September 19, 1985

Serial No. 85-681  
 NO/WRB:cfm  
 Docket Nos. 50-281  
 Licensee Nos. DPR-37

VIRGINIA ELECTRIC AND POWER COMPANY  
SURRY POWER STATION UNIT 2  
ASME XI - INSPECTION RELIEF REQUEST

SEAL WATER RETURN FILTER

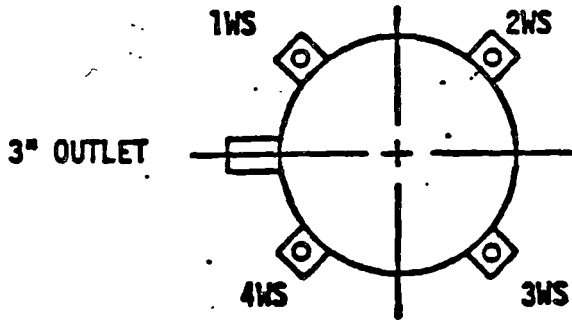
The seal water return filter (2-CH-FL-3) is classified ASME Class 2 in the first interval inspection plan (ASME XI 74 edition, Summer 75 addenda). The following items were scheduled per table IWC-2600 to be completed during the refueling outage on the seal water return filter:

Table IWC-2600 Item No.	Table IWC-2500 Examination Category	Parts to be examined (attachment 2)	Method
C1.1	C-A	1" head to shell weld(1)	*substituted surface and visual
C1.1	C-A	1" shell to flange weld(2)	*substituted surface and visual
C1.1	C-A	1" top head weld(3)	*substituted surface and visual
C1.3	C-C	Welded support (IWS)	surface

Preinspection meetings with the Health Physics Department determined that unreasonable doses would result from completion of these examinations. The close quarters surrounding these components limit shielding and allow effective use of only one individual to remove insulation (Regen Hx only), perform necessary surface preparation, perform the inspection, and reinsulate (Regen Hx only). In addition surface preparation time can be extended significantly as a result of the limited preservice examination requirements associated with the earlier codes. In many cases this has left these type of welds in poor surface condition for examination.

**VALVE OPERATING NUMBERS  
RESIDUAL HEAT REMOVAL**

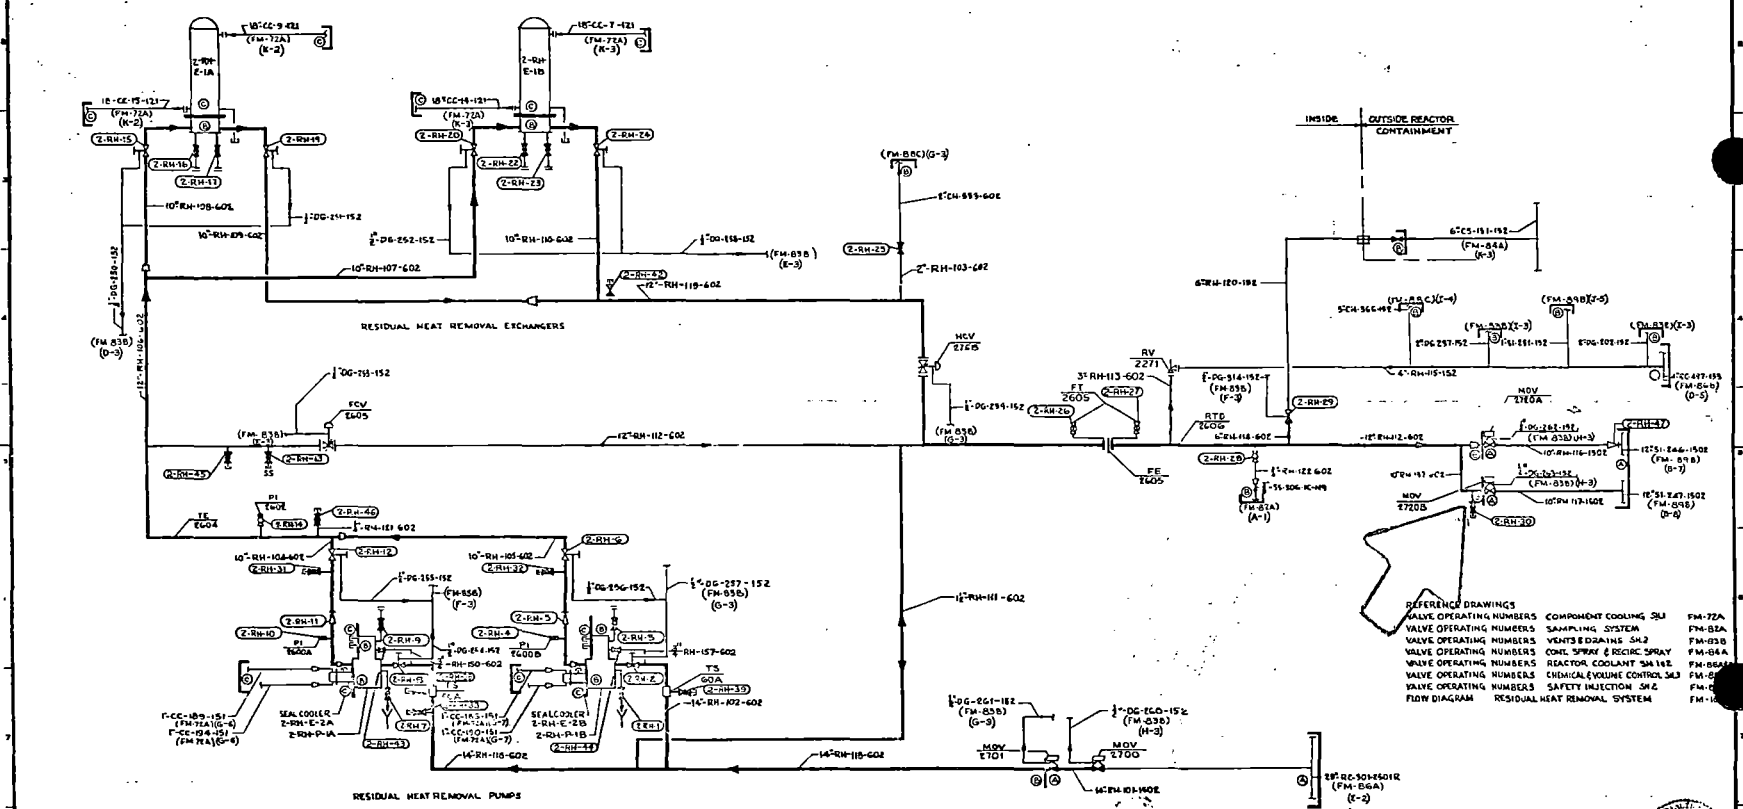
2. The residual heat removal return isolation valve (MOV-RH-2720B) is classified ASME Class 1 (attachment 3). A Table IWB-2600, (ASME XI 74 edition, Summer 75 addenda) item B6.7, category B-M-2, valve internal visual inspection was required this refueling outage. A substituted thickness measurement examination from the exterior wall was attempted. This alternative was approved by relief request on January 24, 1984 (letter Mr. Varga to Mr. Stewart), relief request SR-1.

Therefore, it is requested that acceptance of the system hydrostatic pressure test be allowed as the alternative examination requirement. These tests (Class 1 to Class 2 boundary valve) were completed with the associated VT-2 examinations on July 1, 1983 and April 22, 1985 at test pressures of 600 psig and 750 psig, respectively.

ULTRASONIC THICKNESS REPORT  
NDE-UT-FORM 5

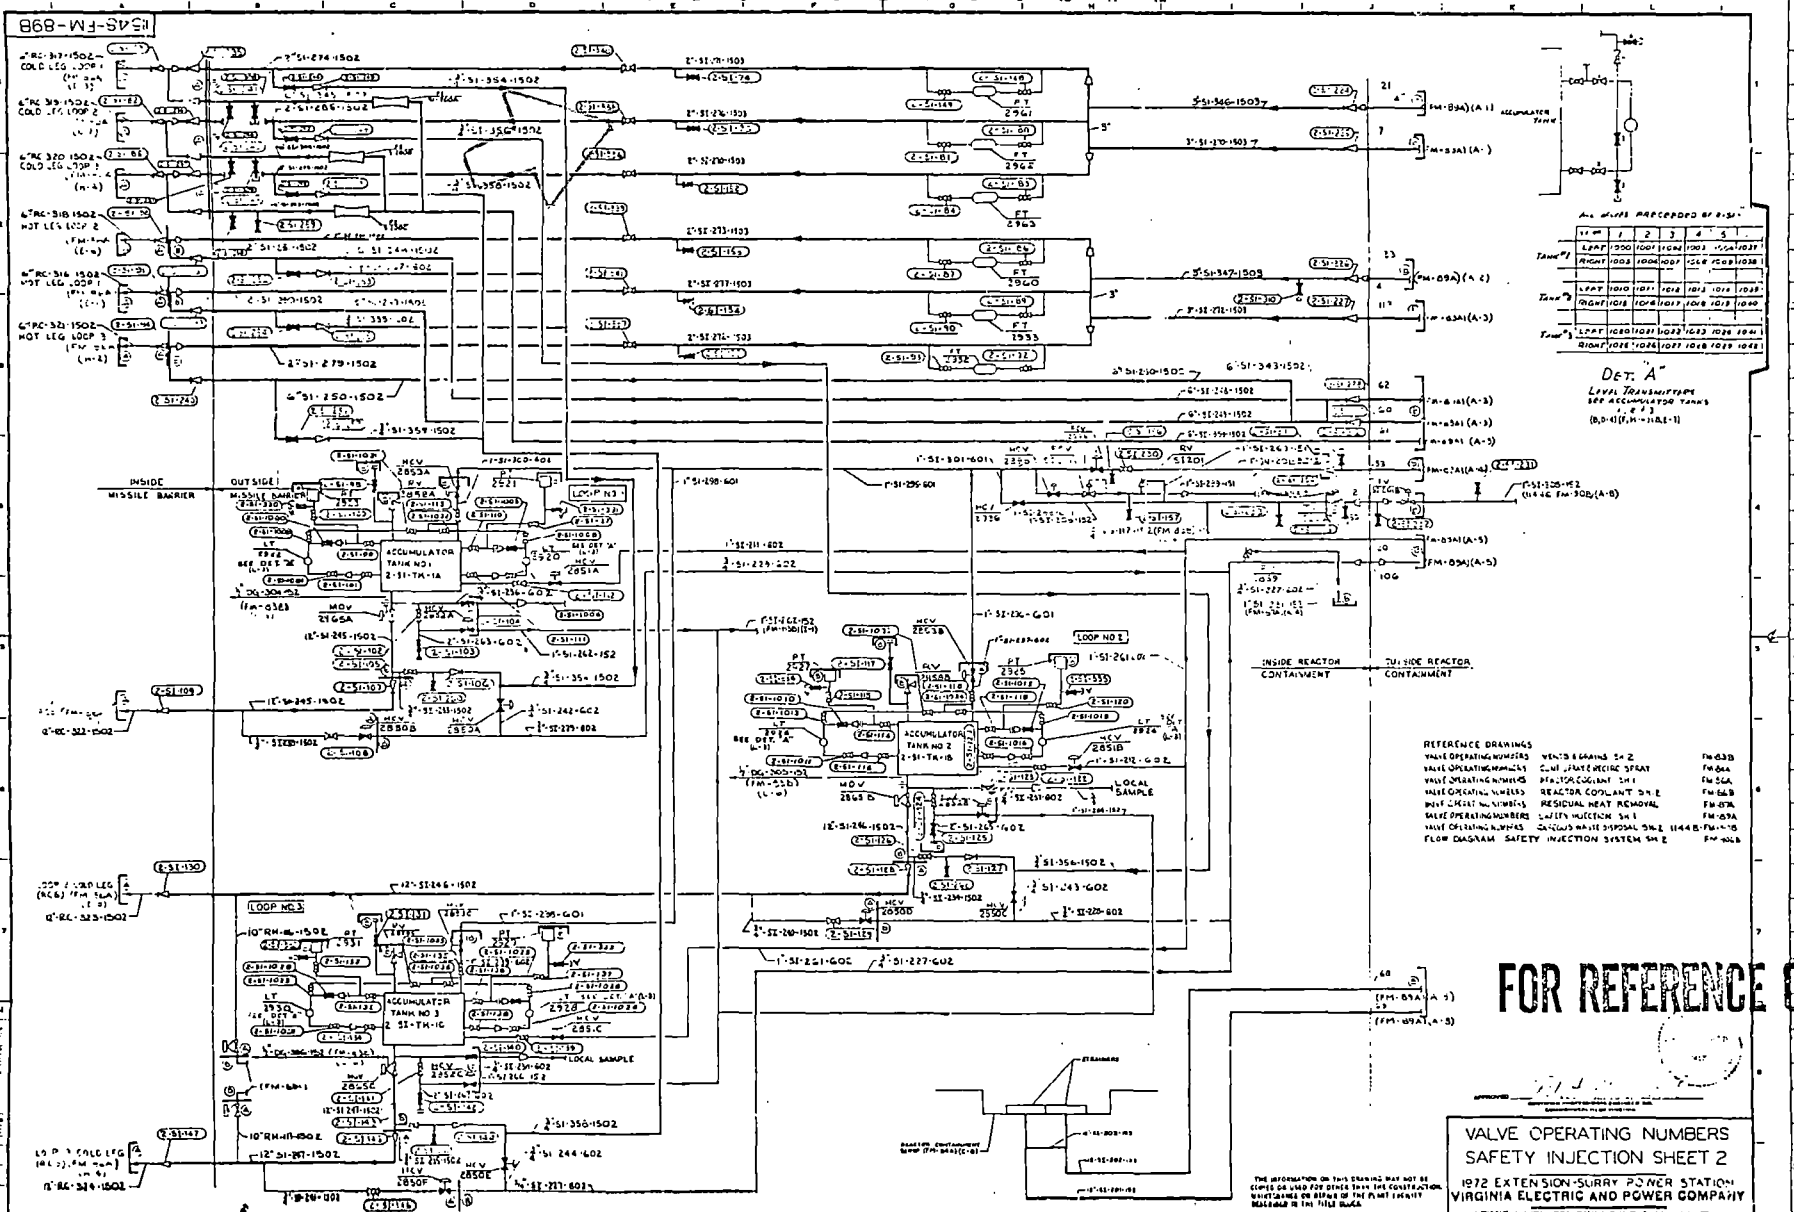
As noted by the attached inspection form (attachment 4), accurate thickness readings could not be achieved. By previous agreement (phone conversation Mr. Neighbors et al, NRC and Mr. Hegner et al, Vepco, March 21, 1985) relief from the thickness measurement requirement would be addressed on an individual basis.

LOCATION	READING	LOCATION	READING	LOCATION	READING
Valve # <sup>19</sup> 2720B	<sup>20</sup> Note; Unable to achieve backwall				
possibly due to	high attenuation of coarse grain				
structure	JSB 5-24-85
